**Re:** Proposed 8 lot single family residential subdivision Rural Area (RA)  
Project Narrative  
10600 N EL MIRAGE RD  
EL MIRAGE 85335  
CRUX Project No. 22.030

# PULIDO SUBDIVISION PRELIMINARY PLAT

Review Status: 2nd Review

Pulido Subdivision Pre-plat PZ22-11-30

DRAWING NO.: C-1  
SHEET 1 OF 1

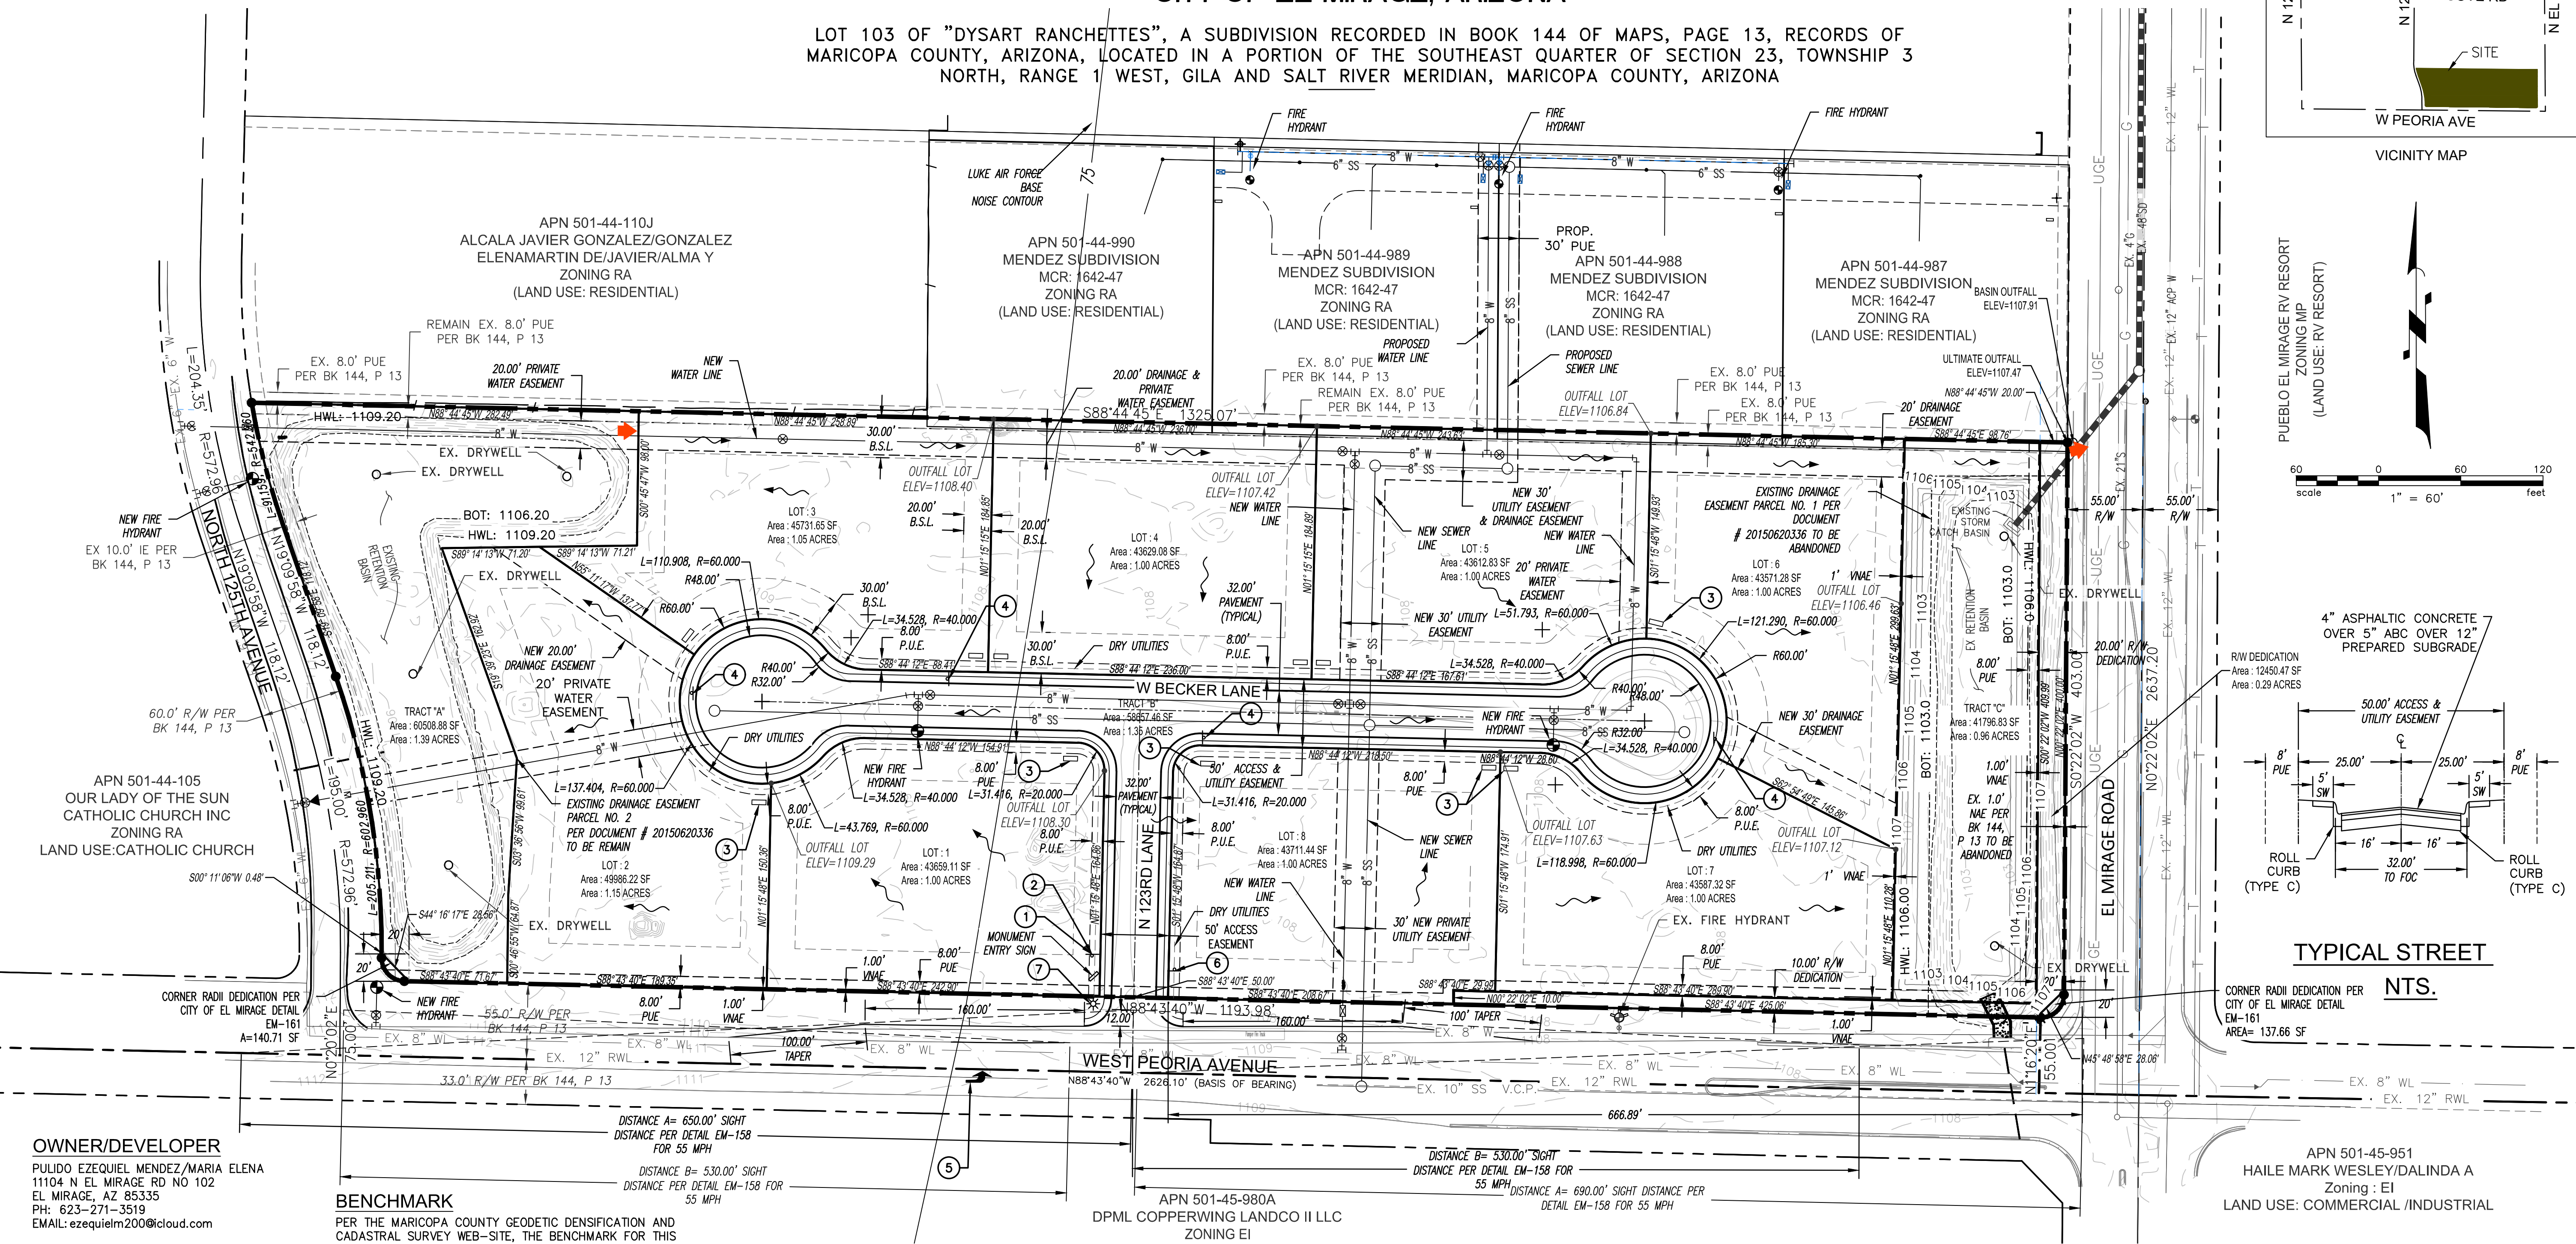
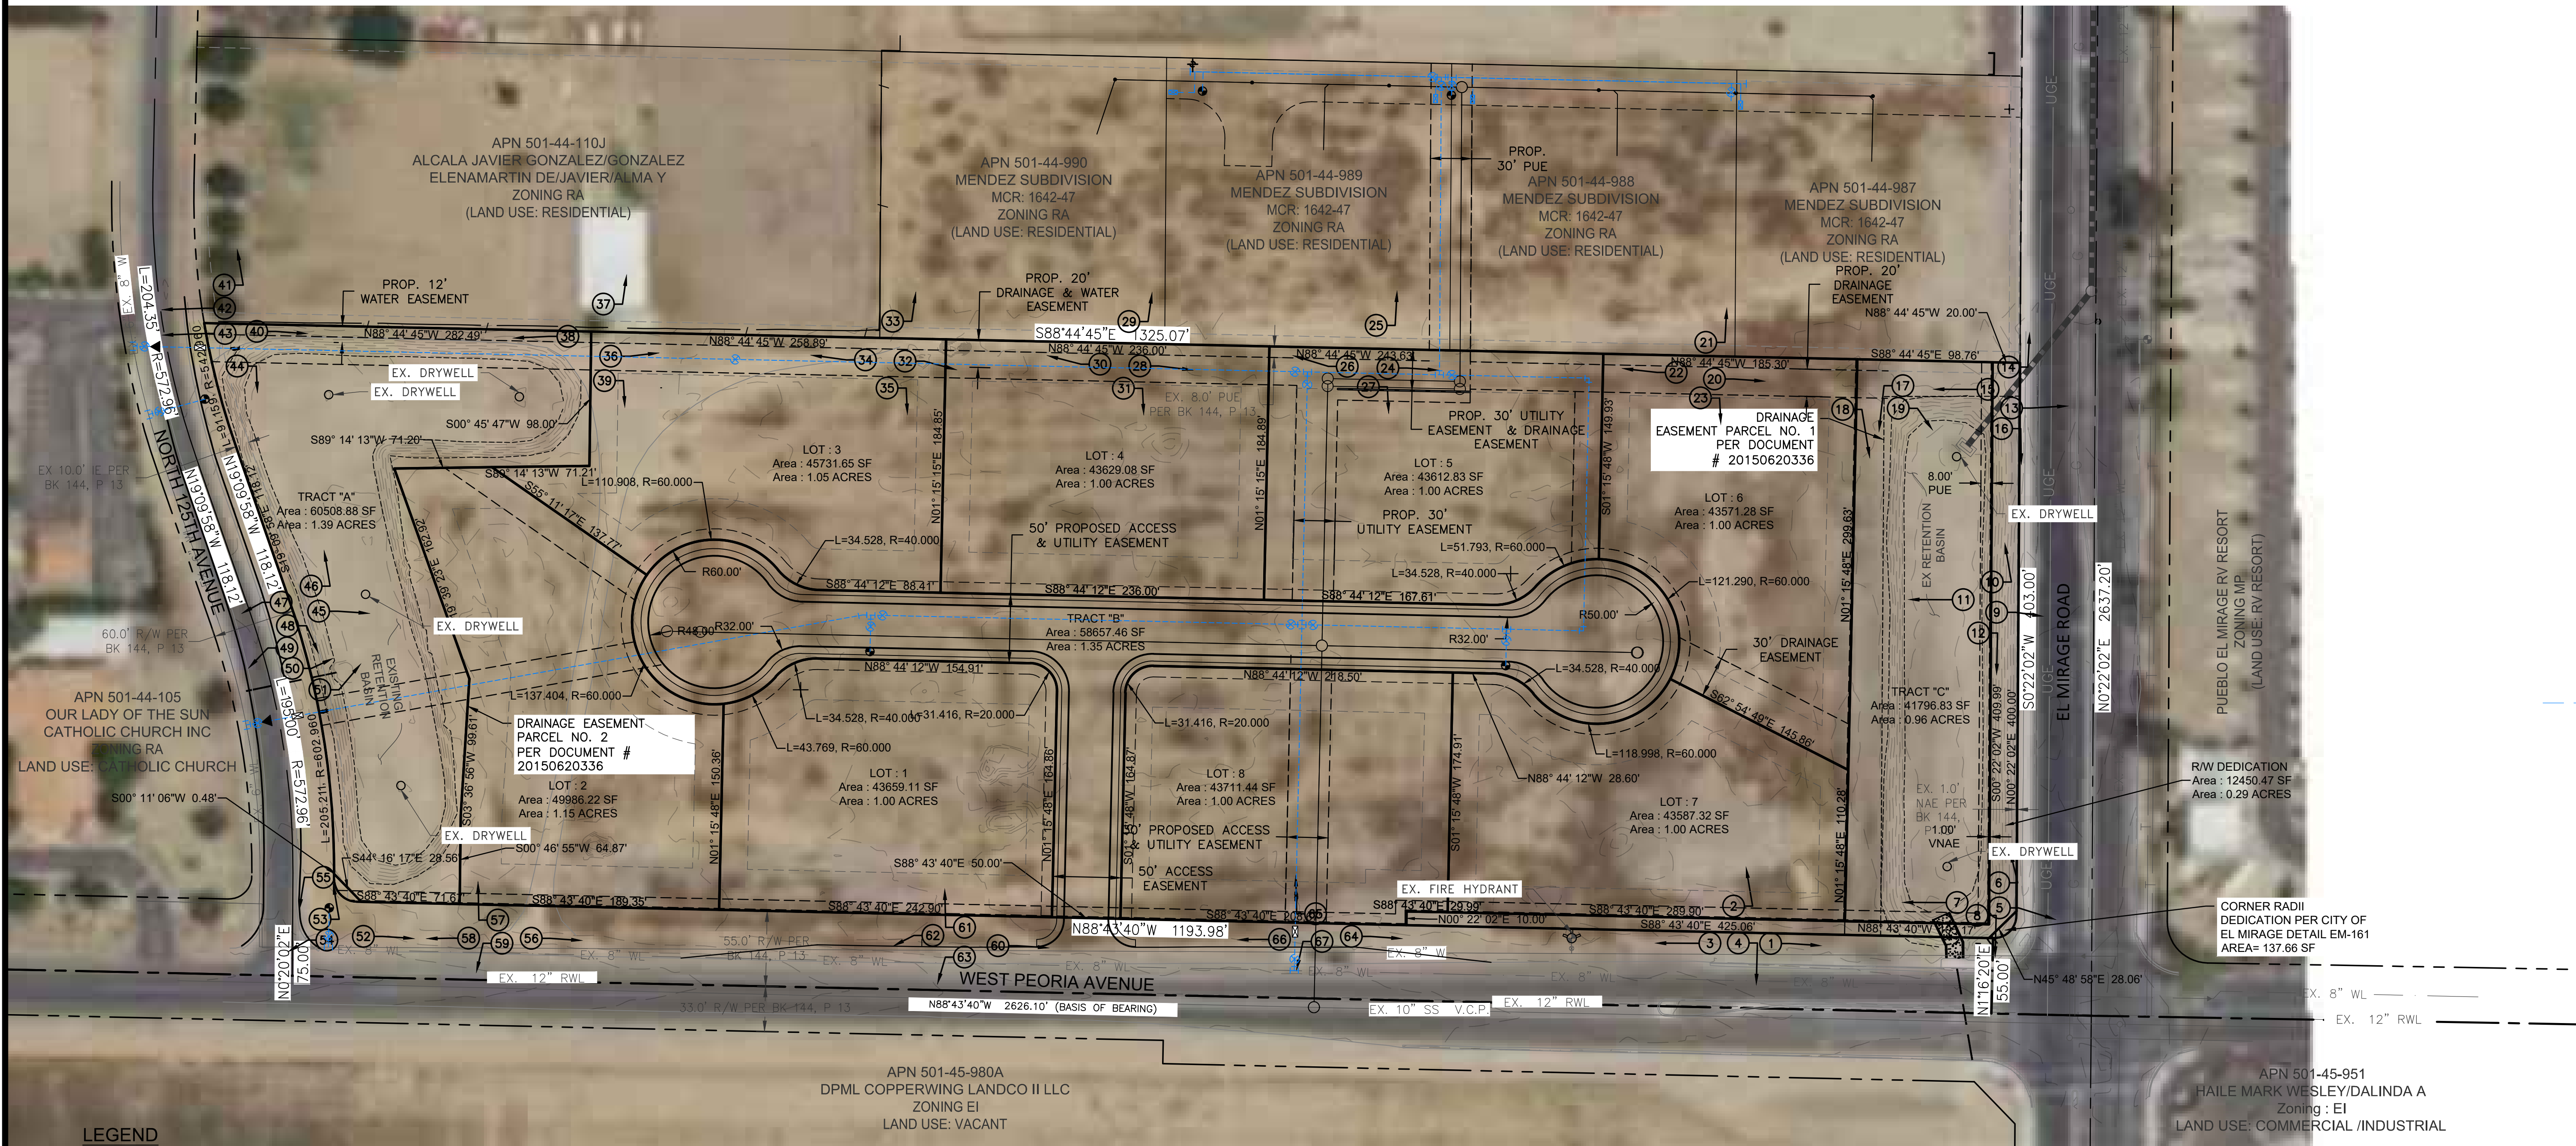
Item	Comment	Reviewer ID	Addressed?	Consultant comment
<b>PLANNING &amp; ZONING</b>				
5	Net lot area, for conformance with the minimum required lot area for the zoning district, shall not include the street easement or tract area. See attached plat redlines. Lot gross area inside TRACTS shall not count as part of the zoning 1.0-acre requirement.	Jose A. Macias	yes	The revised lot layout has been updated to accommodate this.
6	A Preliminary Landscape plan shall be submitted with the final plat per zoning code section 154.102, where El Mirage Road, Peoria Avenue, and 125th Avenue shall be landscaped including the areas in the City's right-of-way.	Jose A. Macias	yes	Preliminary landscape plan updated
7	7.Please see the El Mirage Zoning Code Chapter 155, FINAL PLAT: REQUIREMENTS AND REVIEW section B, Required Final Plat Supporting Materials, for submittal documents requirements.	Jose A. Macias	yes	These itames will be prepared once planning commission approves the revised pre-plat

<b>MEMORANDUM</b>				
<b>Narrative</b>				
1	1.Location and Description –The existing drainage easements will need to be extinguished and re-written for the new site/property owner.			Updated narrative
2	2.Water a.The water mains, hydrants, all associated appurtenances will be private. b.The existing water main in Peoria Avenue is an 8-inch PVC main. Size on size taps are not allowed so the main will need to be shutdown per the City's Scheduled Water Shutdown Procedures.	Bryce Christo, P.E.,	yes	This work has already been completed and approved by MCESD, please refer to that approved set. An 8"x8" tee is already shown as indicated on those set of plans.
<b>Preliminary Plat/Site Plan</b>				
1	Private streets shall conform to City standards and shall include an easement for utility and public safety access at least equal to the City standard right of way for local, residential streets. The asphalt section shall be a minimum of 3" AC over 6" ABC. Comments from the design consultant states that the private streets will not have curb or sidewalk but both are required and both are included in the Typical Street Section shown on the Preliminary Plat	Bryce Christo, P.E.,	yes	All private streets conform to city standards now

2	Assuming the proposed driveway/roadway is designed to be full access, the project will be responsible for a westbound right turn deceleration lane and eastbound left turn lane as Peoria Avenue is considered a major arterial street. The City requires a minimum of a 160 foot storage lane and a 100 foot taper.	Bryce Christo, P.E.,	yes	This is provided and shown on the pre-plat and mentioned in TIS
3	The "No Parking" signs shall be 24"x24". These signs will be required on both Becker Lane and 123rd Lane with spacing not to exceed 250 feet.	Bryce Christo, P.E.,	yes	This has been noted under parking requirements notes in the pre-plat
4	Construction Notes a.Note 1 – Private street name signs are allowed but they cannot be green and white so as to not cause confusion with a public street. The HOA will be responsible for the maintenance of the private street name signs.  b.Note 3 – Revise UPS to USPS. c.Note 6 - At the entrance into the subdivision, the curb shall be imprinted with "PRIVATE STREET – NO CITY MAINTENANCE" in 2 inch high letters.	Bryce Christo, P.E.,	yes	Notes revised as noted.

8	Show surface water drainage arrows.	Bryce Christo, P.E.,	yes	Preliminary proposed flow direction arrows shown.
9	Show the basin high water elevations, bottom elevation, overflow elevations and the ultimate outfall of the site.	Bryce Christo, P.E.,	yes	Added to pre-plat

10	The project site must accept/retain the water generated from the parcel as well as the half right of way of El Mirage Road, Peoria Avenue and 125th Avenue along the project frontage	Bryce Christo, P.E.,	yes	This has been noted in the report and this runoff is intended to be retained by the existing basins as there is already drainage infrastructure in place to collect the runoff
11	The finished floor elevations of the proposed buildings shall be a minimum of 12 inches above the 100-year base flood elevations and high-water level of any adjacent retention basin and 14 inches above the ultimate outfall of the site.	Bryce Christo, P.E.,	yes	This note has been added to the pre-plat under drainage statement and also stated in the preliminary drainage report
12	The existing and proposed retention basins shall be located a minimum of 4 feet away from any structures and shall not be located within any building setbacks, easements, or fire lanes. The west basin is within the proposed 20 foot Private Water Easement. A Design Exception may be requested to allow the encroachment but there is no guarantee the request will be approved.	Bryce Christo, P.E.,	See response notes	This has been noted in the drainage report. In regards to the water easement, an exception request will need to be applied for. The looping of the water line is required to meet the fire flows and this is the only feasible option to loop the water and provide adequate fire and water supply to the Mendez and Pulido Subdivision. The Mendez subdivision offsite water and sewer plans have been approved already , so we ask to take this into consideration when reviewing the design exception request. Adequate protection and cover was provided by encasing the water main as requested during the design review of the Mendez Subdivision and follow COM Section

13	The existing and proposed retention basins shall not be located within the City right of way. The east basin will be encroaching into the right of way along El Mirage Road.	Bryce Christo, P.E.,	yes	This has been revised, preliminary design contours are shown on the pre-plat as the basin will need to be re-graded to address this.
	<b>Utility Plans</b>	Bryce Christo, P.E.,		
14	For 30 foot wide easements with both sewer and water, it is recommended to keep the mains 10 feet from the edge of the easement and 10 feet from each other. For 20 foot wide easements with only one utility, the main shall be centered.	Bryce Christo, P.E.,	See response notes	We already went thru the review and approval process with the City and El Mirage. We felt that comment should have been provided at that time. We propose to leave this as is as we will have to start the review process again with MCESD.
15	The Utility Plans shall show all existing and proposed utilities and utility easements including electric, gas, phone and cable.	Bryce Christo, P.E.,	yes	8' PUES have been added to the pre-plat

19	The hydrants shall be located within the Water/Utility Easements.	Bryce Christo, P.E.,	yes	All hydrants are located either within the private access road easement and/or within a public ROW.
20	The minimum domestic and landscaping service lines shall be 1 inch per City Detail EM-325 and the minimum sanitary sewer service size shall be 4 inches per City Detail EM-440	Bryce Christo, P.E.,	yes	This note has been added to water & sewer notes and will be done for final construction documents
21	The sanitary sewer services shall have backwater valves per City Detail EM-442.	Bryce Christo, P.E.,	yes	This note has been added to water & sewer notes and will be done for final construction documents
22	Sanitary Sewer Note 4 shall be revised to remove the following "...and installed with a City cover per Detail EM-423."	Bryce Christo, P.E.,	yes	Already shown as such on the approved Mendez Subdivision offsite plans
